ISOLA GREENWOOD

6800 GREENWOOD AVENUE N

DESIGN REVIEW
DPD #3016207
JUNE 23, 2014

RESPONSE TO EDG BOARD COMMENTS

SETBACK AT ADJACENT SINGLE FAMILY

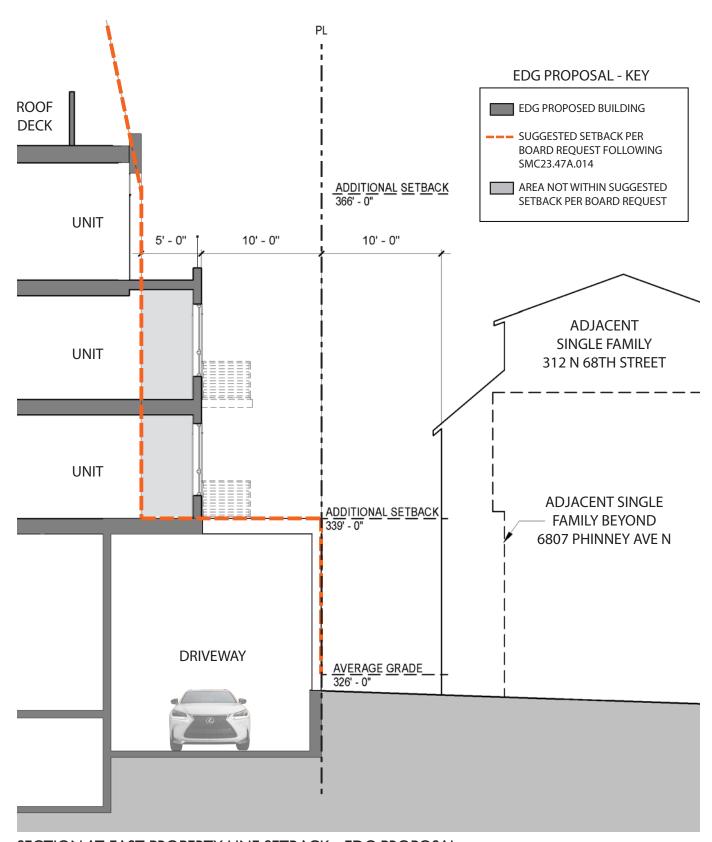
The Board expressed that the proximity to the zone change means this project is essentially at the zone edge and should follow the Greenwood-Phinney guidelines for Height, Bulk and Scale.

- Increase the building setback from the east property line.
- The massing should be oriented towards Greenwood Ave N.
- Consider extending the upper level amenity deck further north.
- Setback the south elevation at grade.

By taking the 60' long garage driveway ramp that was on the property line at EDG and pulling it back flush to the building, over 600 square feet of additional greenspace was added to the setback facing the single-family neighbors. Additionally, the driveway has been enclosed within the building walls to minimize light, noise and odors. The private decks on Level Four are now 6' deep and the main facade has been modulated with small decks that utilize railings with horizontal slats, allowing views to the horizon while blocking line-of-sight to the yards below. The east elevation now provides substantially more buffer space/volume than would typically be required by SMC23.47A.014.B.3 as shown graphically at right.
